THE VILLAGE AT CRICKET LANE
BYFIELD (NEWBURY), MA 01922
ASSESSOR'S MAP R-20 LOT 75

ROADWAY LAYOUT AND PROPERTY LINE PLAN

SHEET 6 OF 30

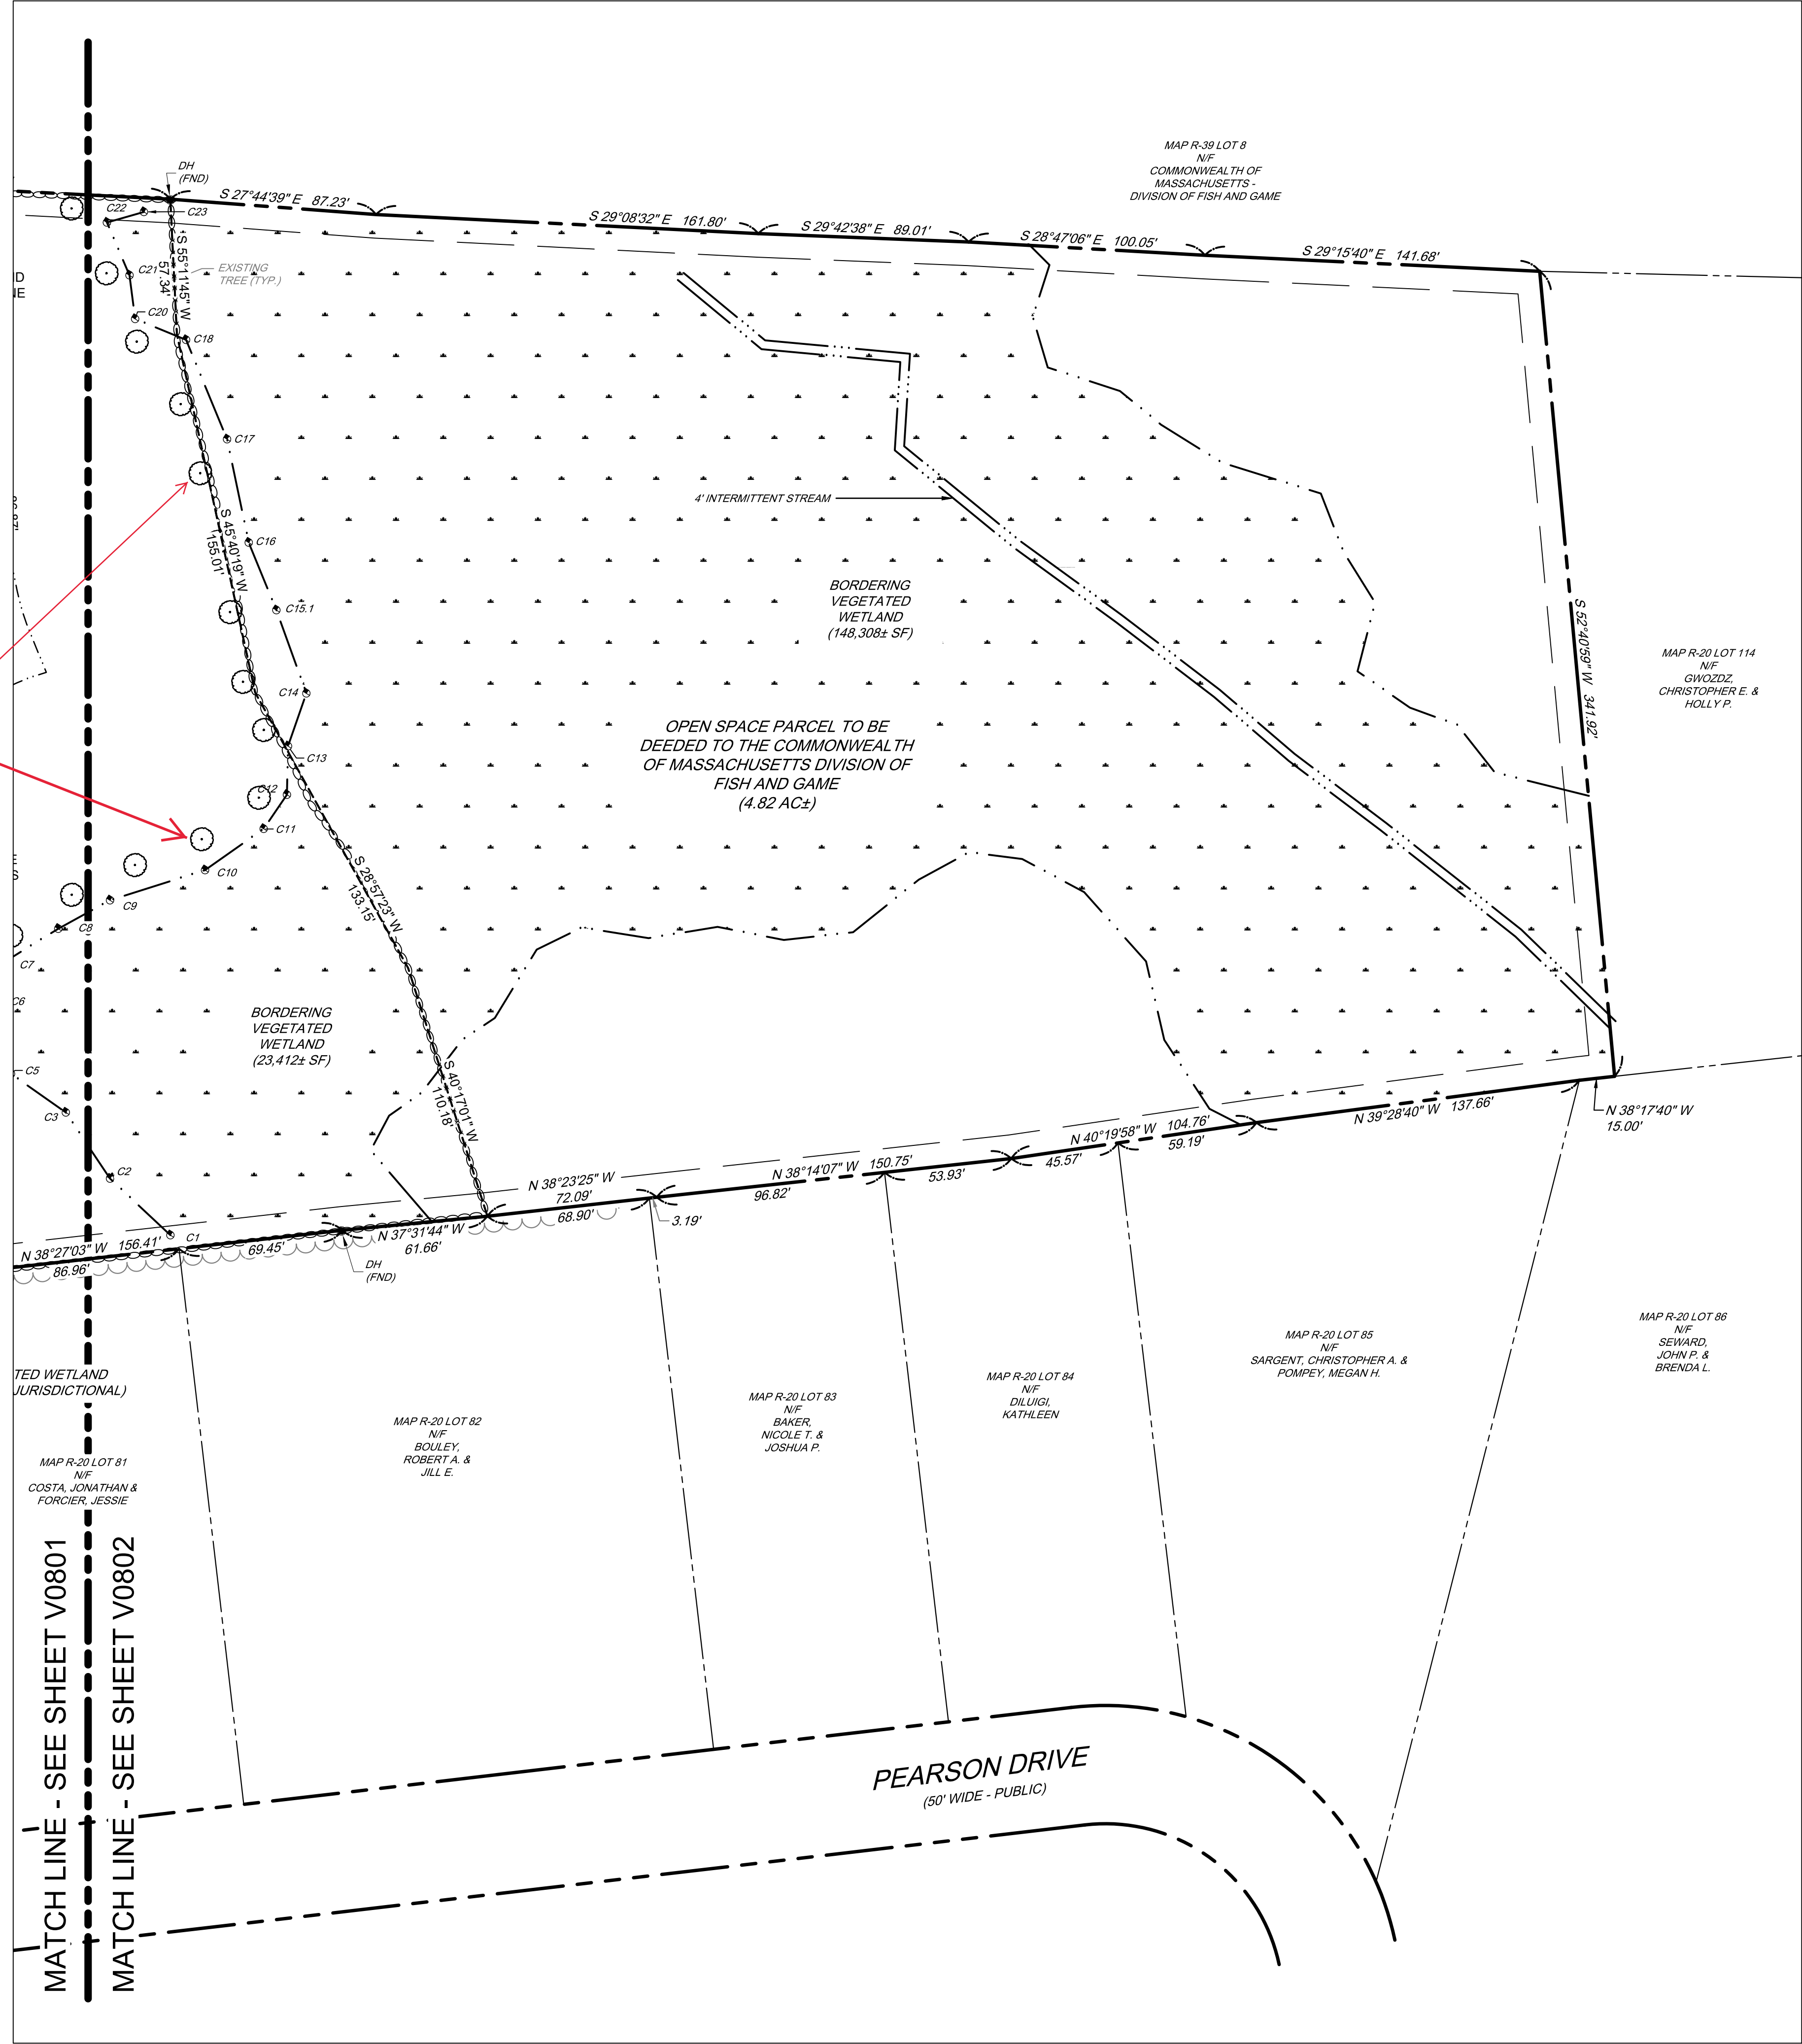
Proposed trees should not be shown on the roadway layout sheet. Remove from this sheet only.

TABLE 1: APPROVED TREES

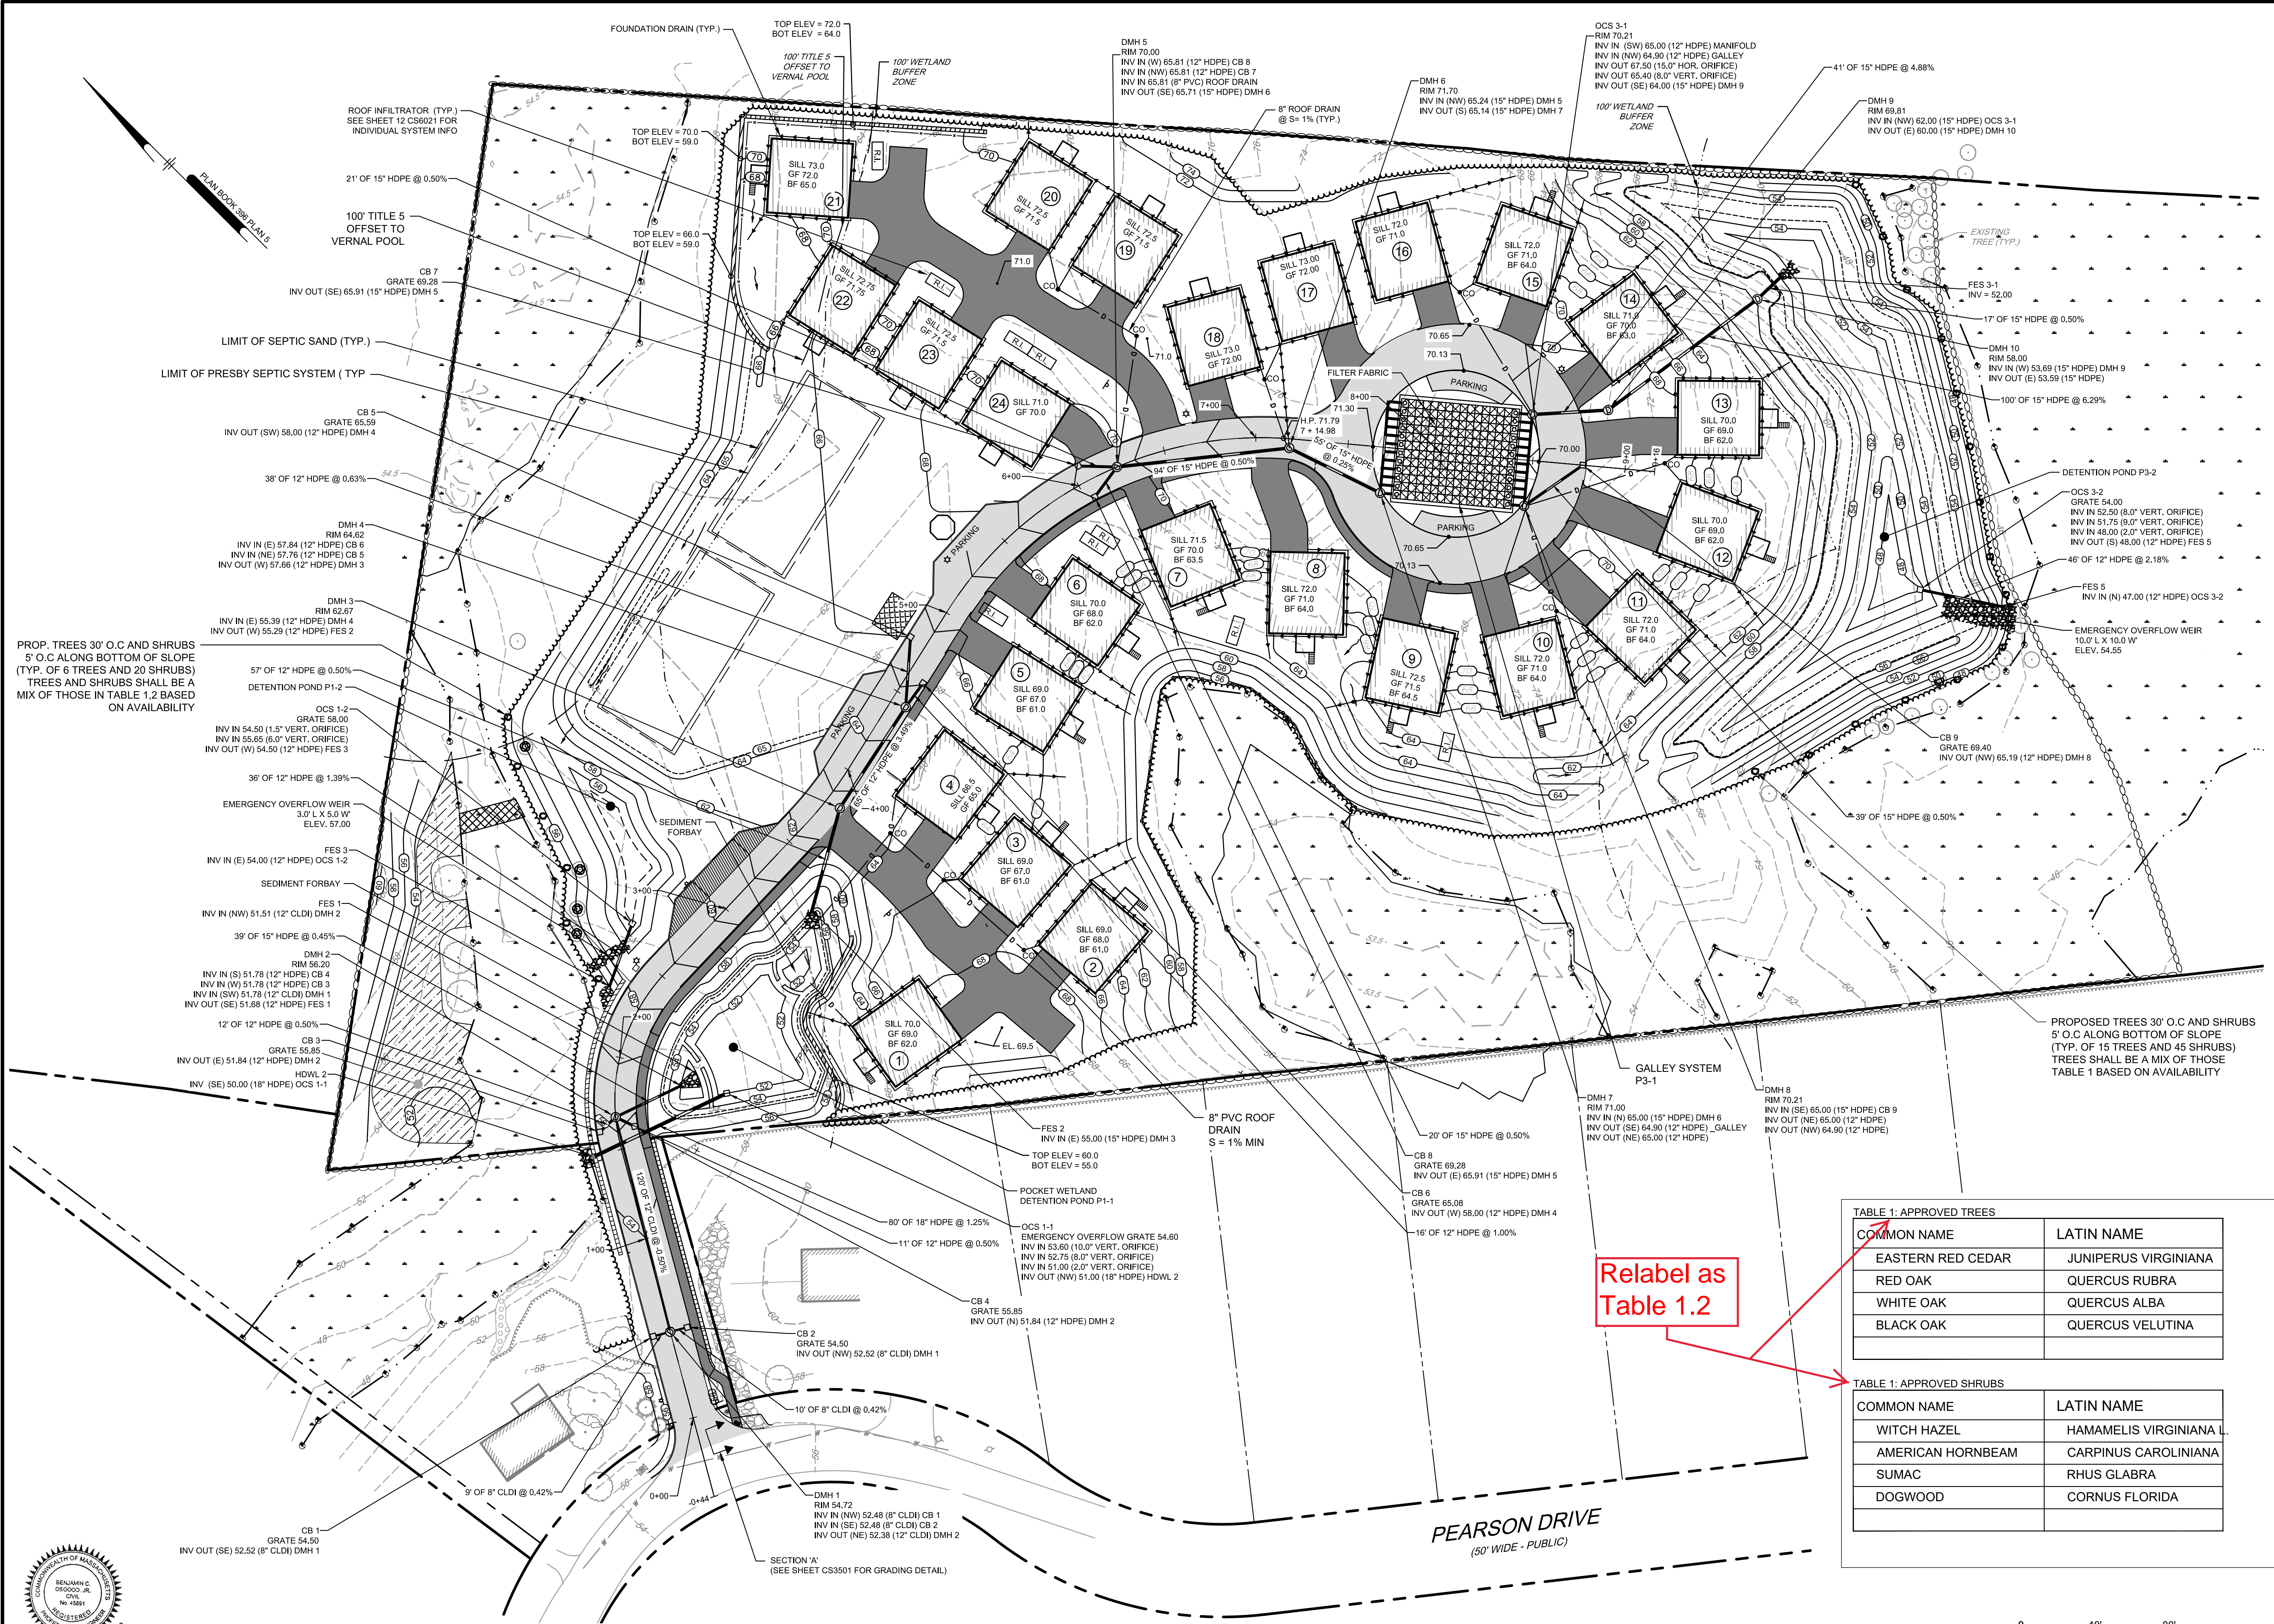
Relabel as
Table 1.2
